**Date:** November 3, 2016

**Subject:** **Prairie Creek Mine, all season road undertaking 7 IR replies – PCA IRs**

This memo responds to PCA IR#2, 3, 8 and 10 from the proposed all season road undertaking 7 information requests.

**SUNDOG CREEK  
FLOODPLAIN ANALYSIS  
OPTION #1**

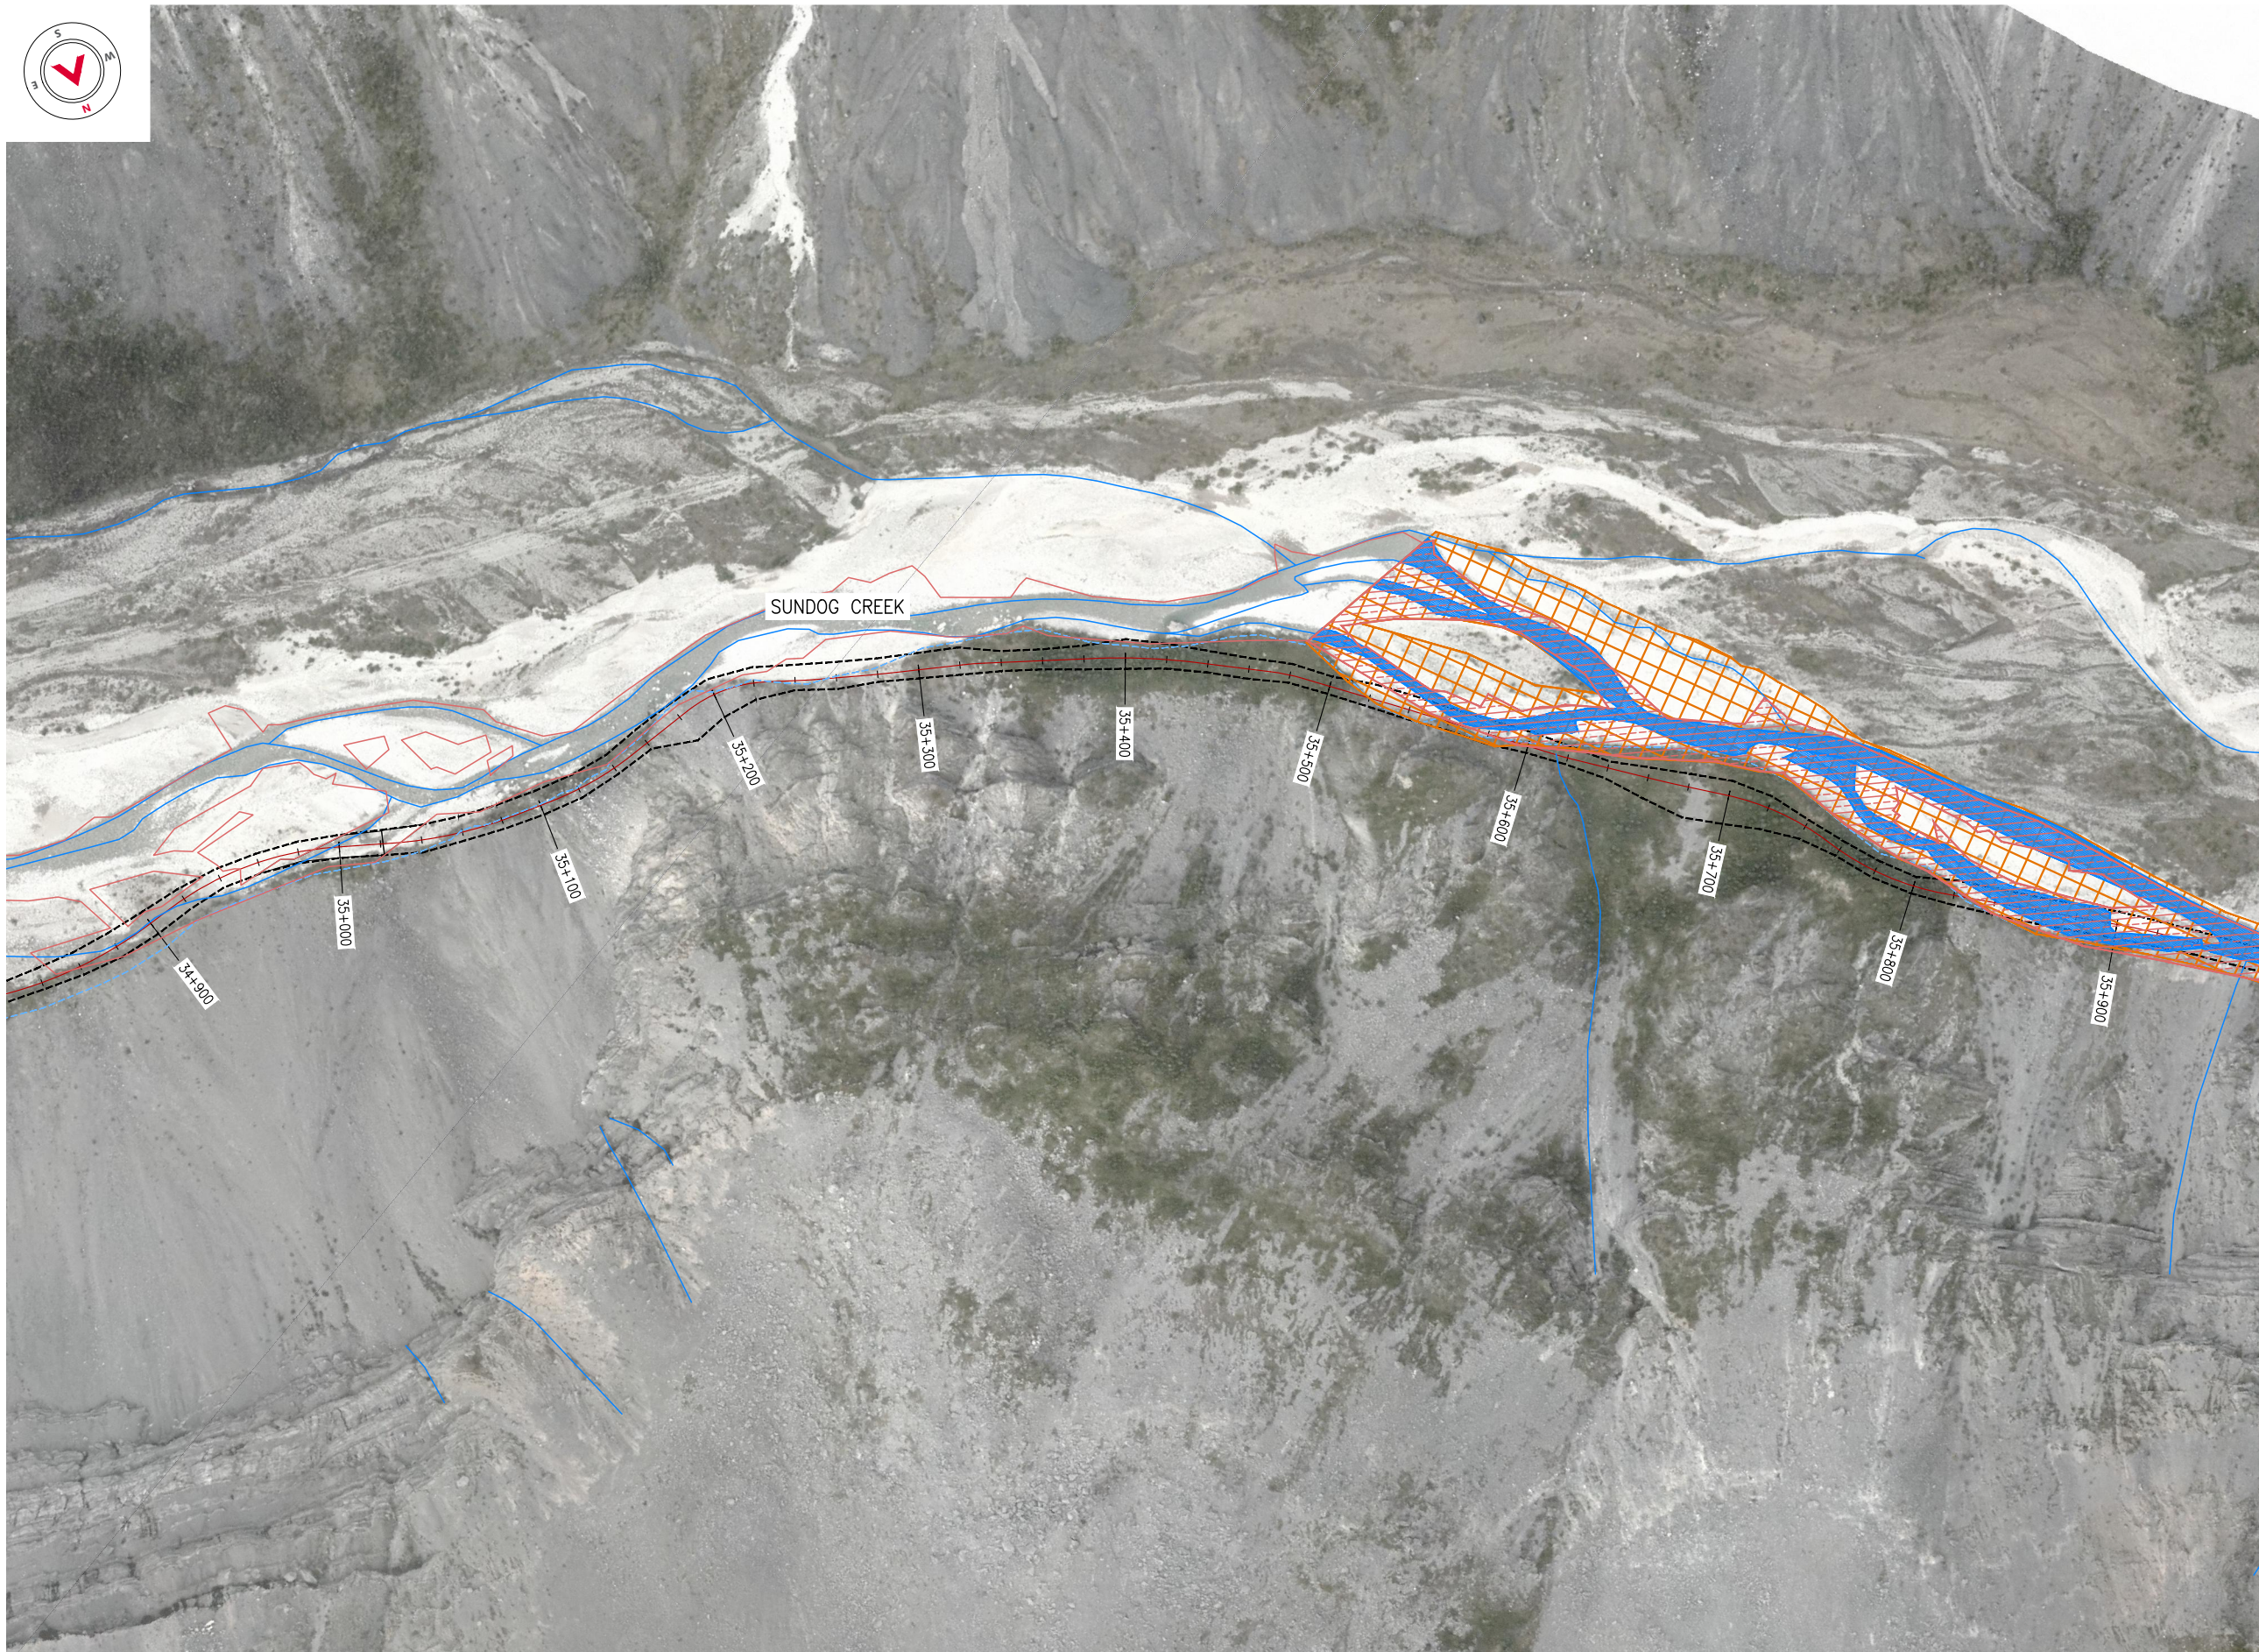
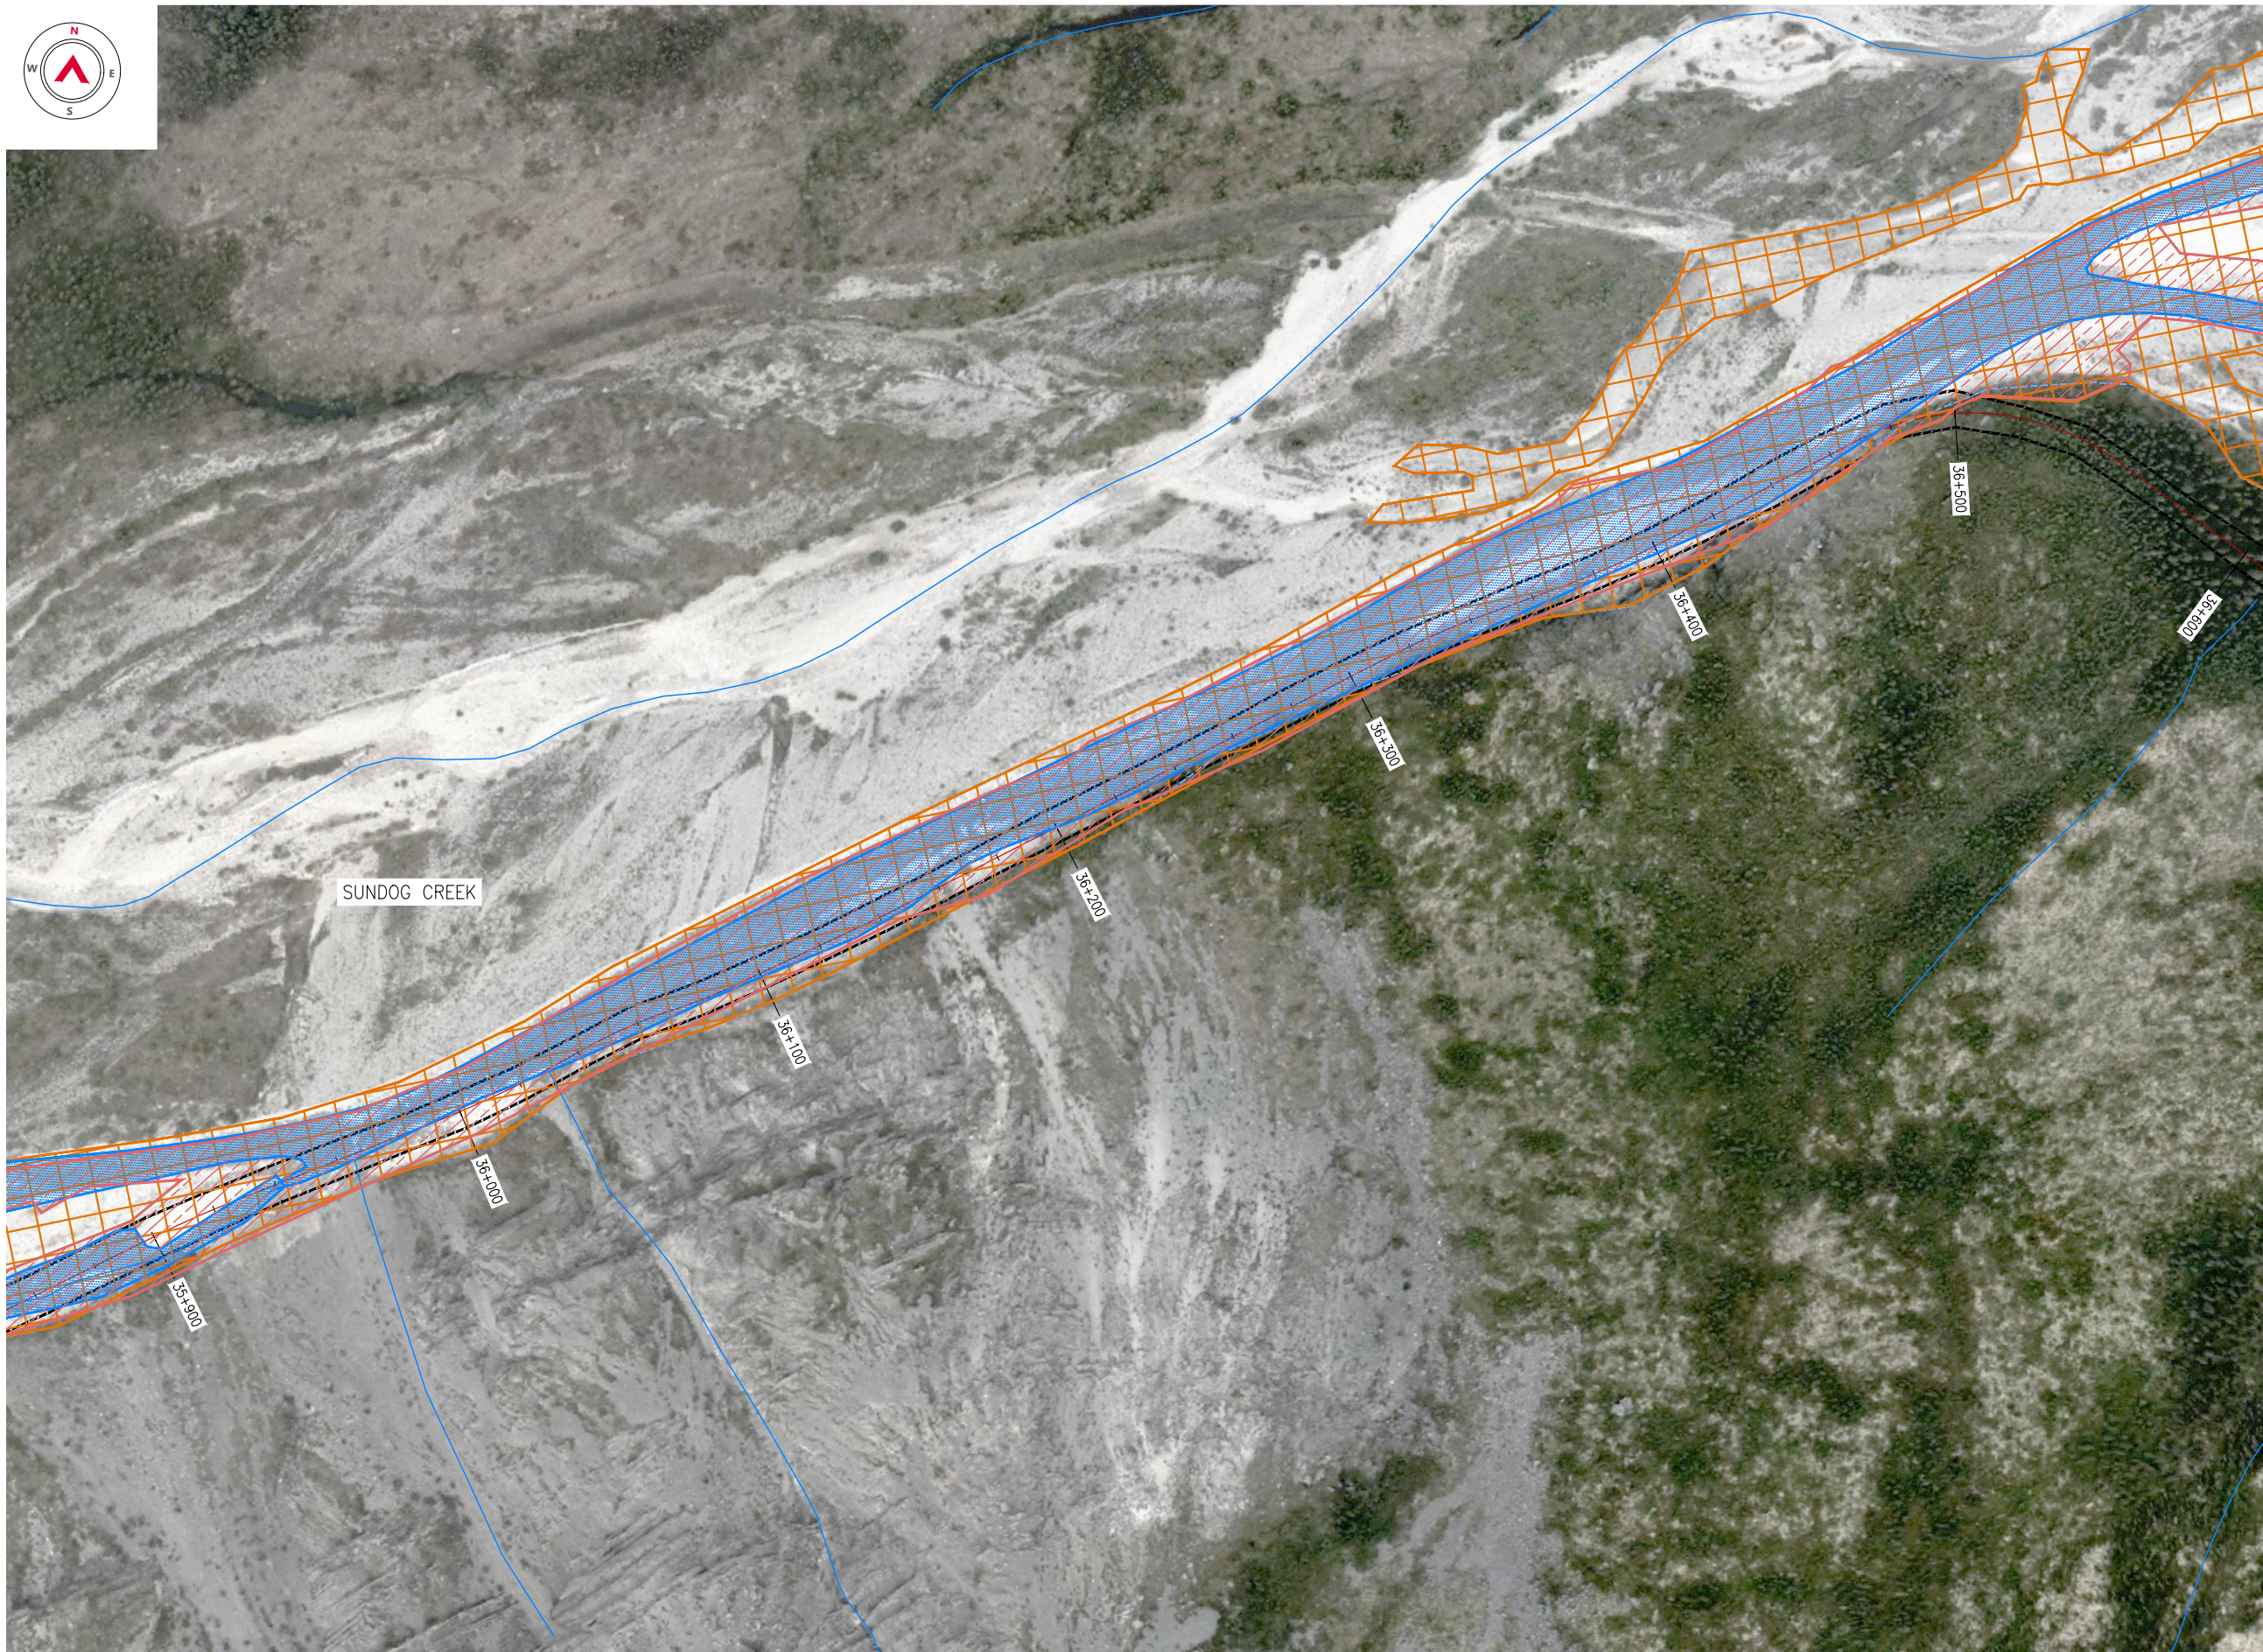
**Comment:** On pages 1 and 2 of a Hatfield Memo, dated September 6th 2016, the proponent describes three categories (A-C) of aquatic habitat and the criteria used to rank the importance of its ecological function with respect to fish. Tables in the back of the document contain estimates (m<sup>2</sup>) of aquatic habitat in each category that will be impacted by this project and their rank. Parks Canada recognizes this work, but requires additional information to properly determine the potential impacts on aquatic habitat from this project. The categories and ranks provided in this Memo lack scientifically based references to justify their use. In addition, the ranking presented focusses solely on the significance of the aquatic habitat for fish and gives no consideration to the other ecological functions it serves. Parks Canada is required to maintain ecological integrity and as such is compelled to consider all of the ecological structures and functions this habitat provides. Also, in IR Round 2 PCA#10, Parks Canada requests that the impacts to the floodplain be assessed using Q20 flow projections and would ask that fish habitat be evaluated using the same flow projection.

**Recommendation:** 1) Provide scientific literature which supports how the categories were applied to the riparian habitat; 2) Provide scientific literature which supports the ranking of riparian habitat that considers all the ecological functions it provides; and 3) Recalculate the amount of fish habitat that will be lost, both temporarily and permanently, for each category and rank using the Q20 flow projections (See IR Round 2 PCA#10).

We have calculated the area of the existing aquatic habitat downstream of the proposed diversion berm that will be altered as a result of diversion. Similar to portions of Sundog Creek within the road prism, the current channel was divided into categories A, B and C. In addition, at the suggestion of DFO (conference call on October 20, 2016), we have calculated the area of a smaller altered area, for an alternative option where flows return to the current channel at km 36.5 instead of at km 37. Area calculations were done using GIS and divided into the following categories: normally wetted main channel, normally wetted side channels, 1:2 flood level and 1:100 flood level minus mature vegetation. The calculated areas are provided in Table 1 and the maps used for the calculations are provided in Attachment 3.
